Groundwater Application Review Summary Form

Application # G- 18563

PUBLIC INTEREST REVIEW FOR GROUNDWATER APPLICATIONS

TO: Water Rights Section Date 1/3/2019
 FROM: Groundwater Section Joe Kemper
 Reviewer's Name
 SUBJECT: Application G- 18563 Supersedes review of NA
 Date of Review(s)

Figure 3. Water-Level Trends in Nearby Wells

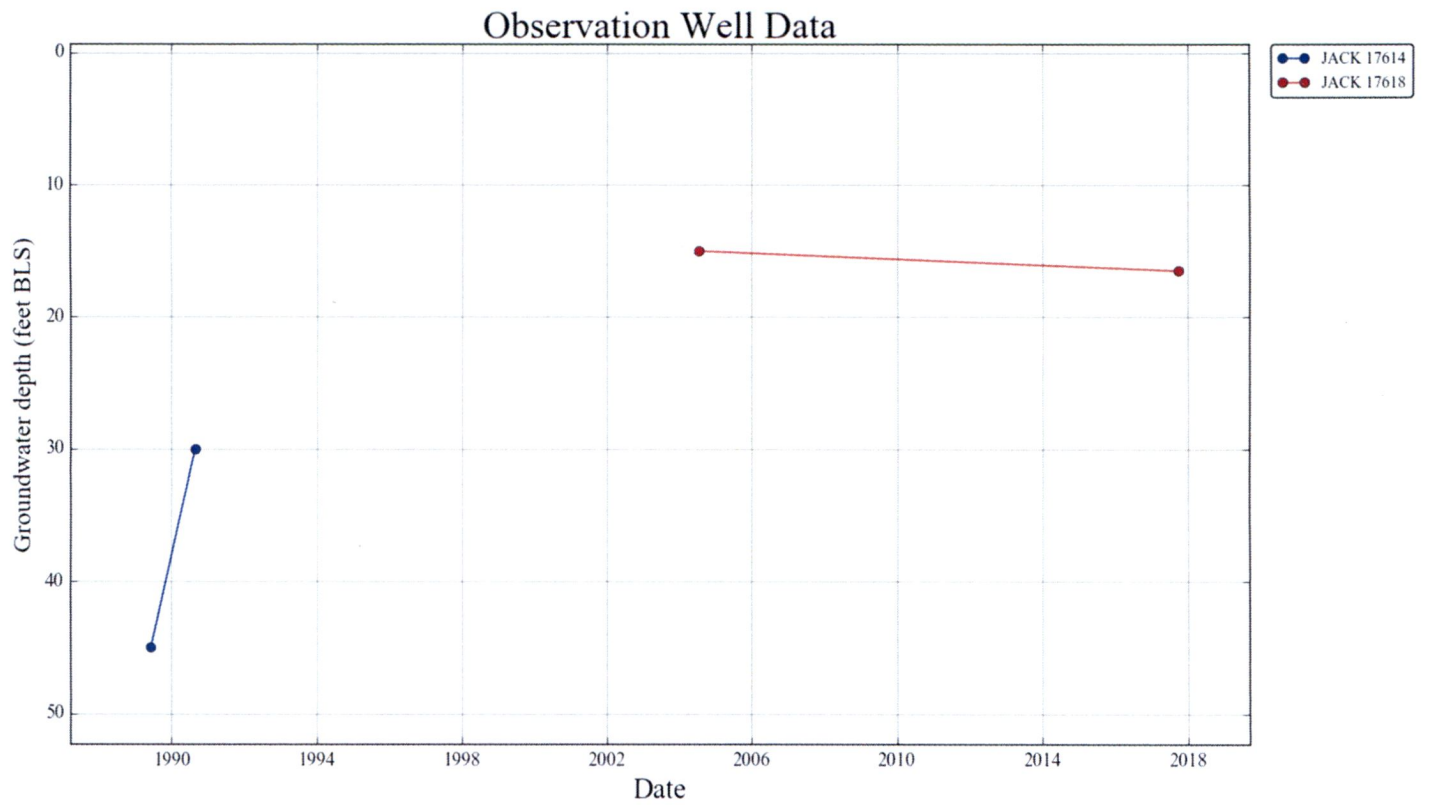
B3. **Groundwater availability remarks:** The applicant’s proposed POA will produce from a fractured bedrock aquifer hosted in meta-volcanics of the Applegate Group. There are very few OWRD observation well data within 1 mile that access the same aquifer system as the proposed POA so aquifer over-appropriation cannot be determined (see Figure 3).

Figure 4. Stream Depletion Model

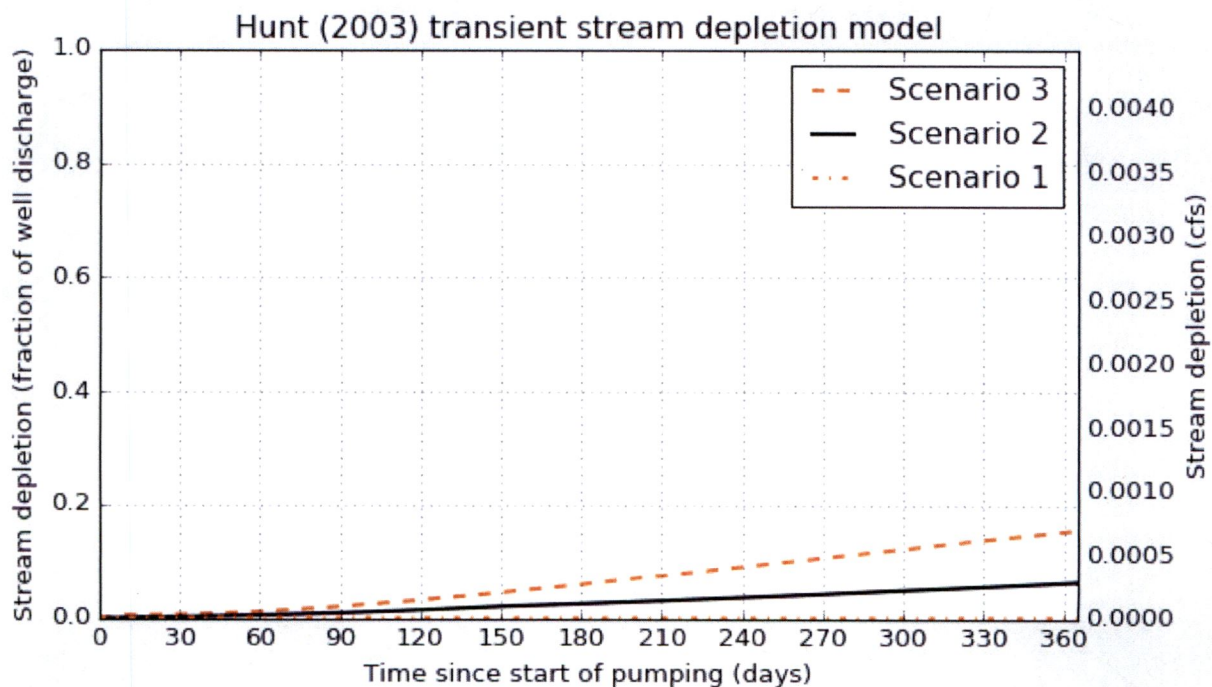
Comments: Pumping effects on adjacent surface water sources are evaluated using the Hunt (2003) stream depletion model with aquifer parameters representative of the local geology. Model parameters and results are presented in Figure 4.

C6. **SW / GW Remarks and Conditions:** The applicant’s well has been determined to be hydraulically connected to the Applegate River. However, there is not a preponderance of evidence that the proposed use/rate has the Potential for Substantial Interference (PSI) as per OAR 690-009.
